RTS FSM for coherent PMDs (comments 140-143, 165-166)

Tom Huber, Nokia

Overview of proposal

Figure 178B-y
RTS with squelch state diagram

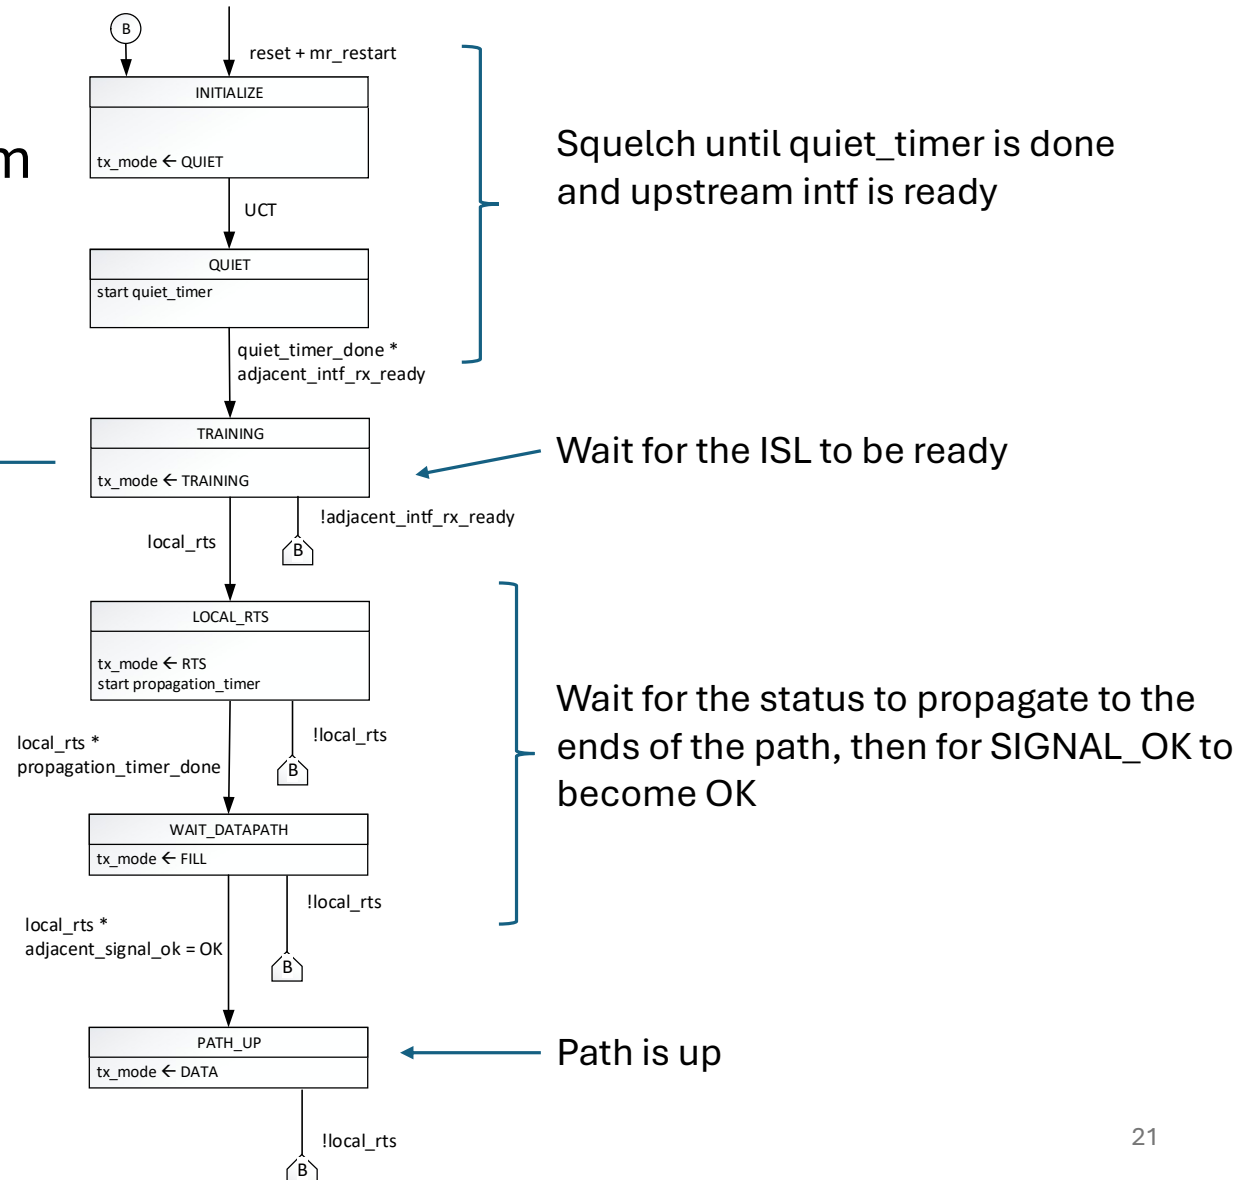
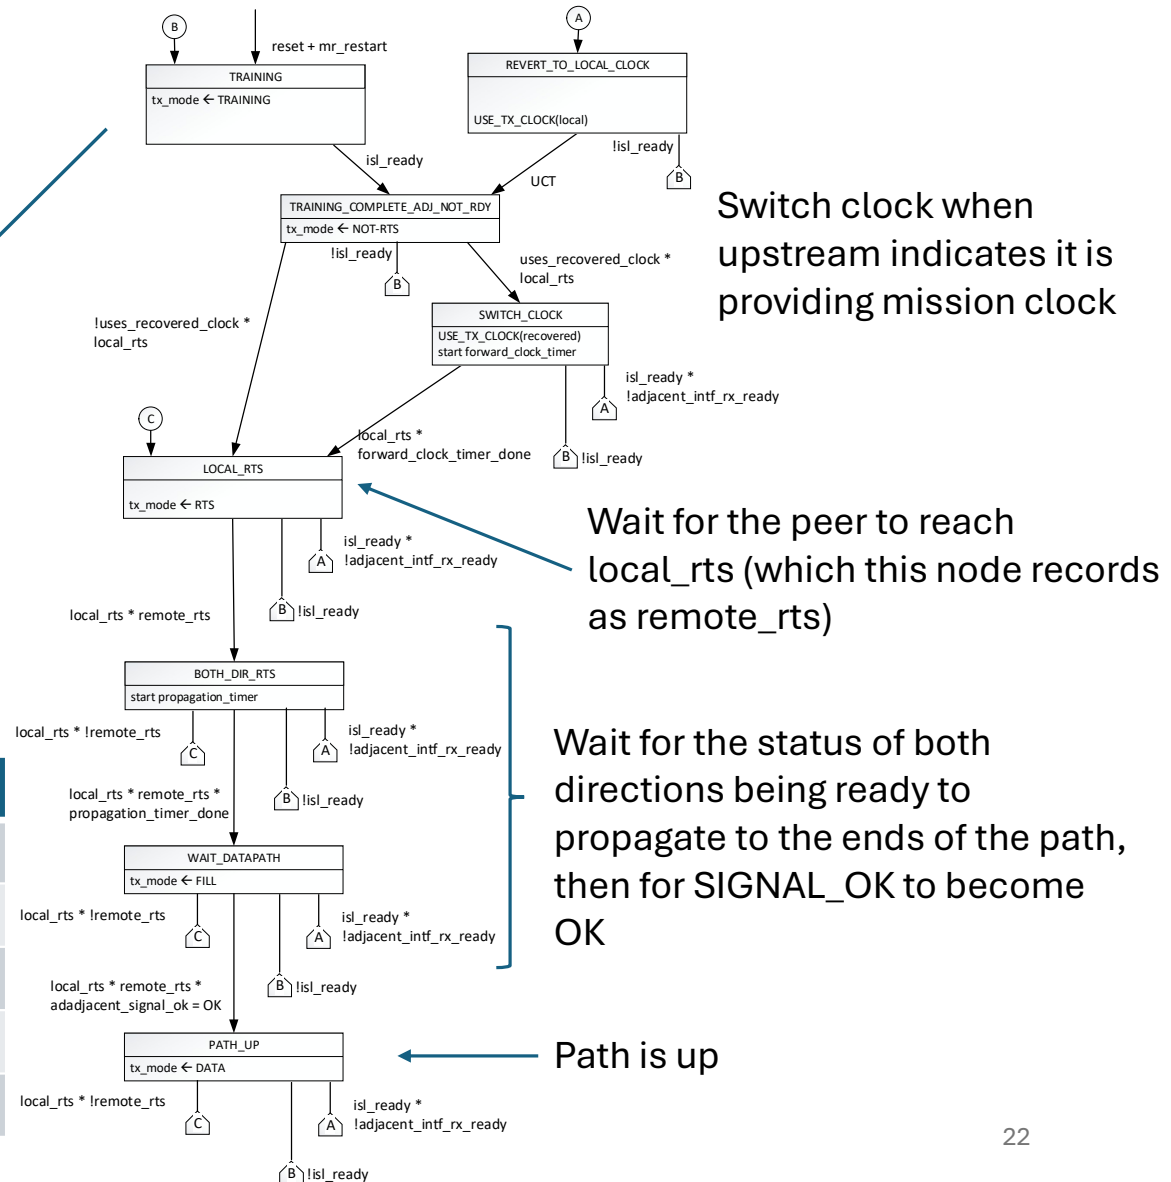
This is used with LR1

“training” means transmitting the test pattern and tuning the rx based on the received test pattern (which may already have been done, or may happen later, since the two directions are independent)

ER1 always transmits on its own clock, so no quiet period is needed, so the FSM starts at TRAINING. Training is complete when frame alignment is complete and the receiver is adjusted

Coherent interfaces that squelch when they are not ready to send shall implement the state diagram shown in figure 178B-y.

Coherent interfaces that do not squelch when they are not ready to send shall implement the state diagram shown in figure 178B-z.
